BendPak TSB 185 – 102025 2-Post Lifts Screw-Adapter Snap-Ring Removal

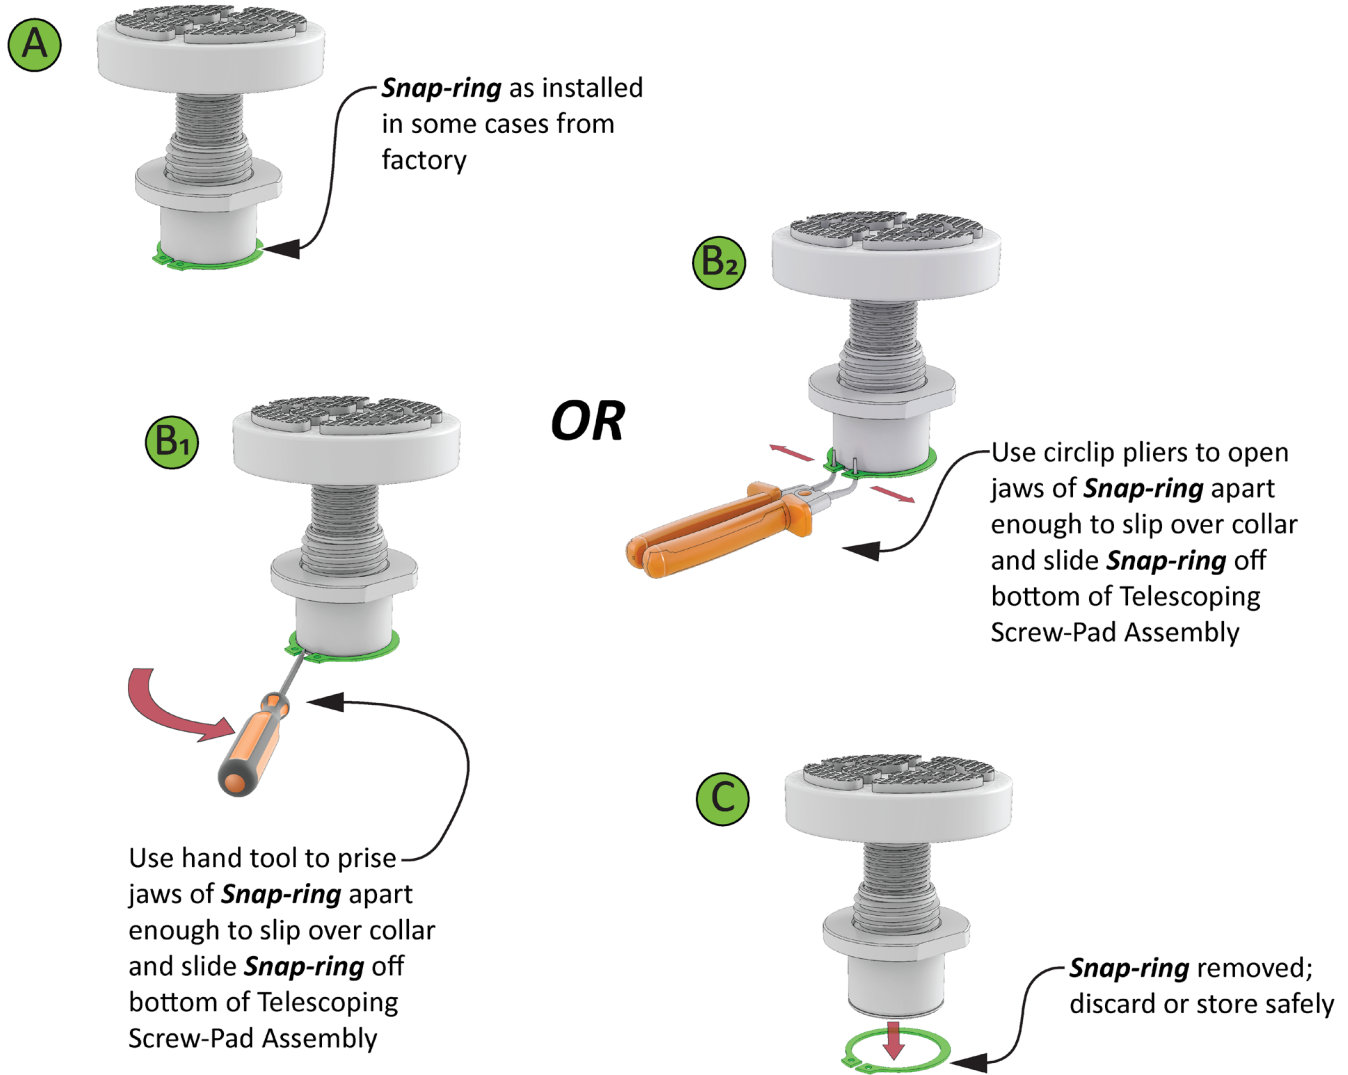
This Technical Service Bulletin describes the removal of a snap-ring on the base of the telescoping screw adapters which support the Lift Pads on 2-post lifts using 50 mm pins in their screw adapters. This TSB applies *only* to Telescoping Screw Adapters which occur as part of assembly **5216333**, with **50mm** pins, shipped with some Apex and GrandPrix 2-Post lifts. Confirm whether or not these snap-rings are present on your lift; if yes, follow this procedure to remove them prior to Lift Pad use.

Removal of the snap-ring requires either a pair of snap-ring / circlip pliers or a flat-head screwdriver to pry apart the ring as shown below. Repeat this procedure on all four Telescoping Adapters.
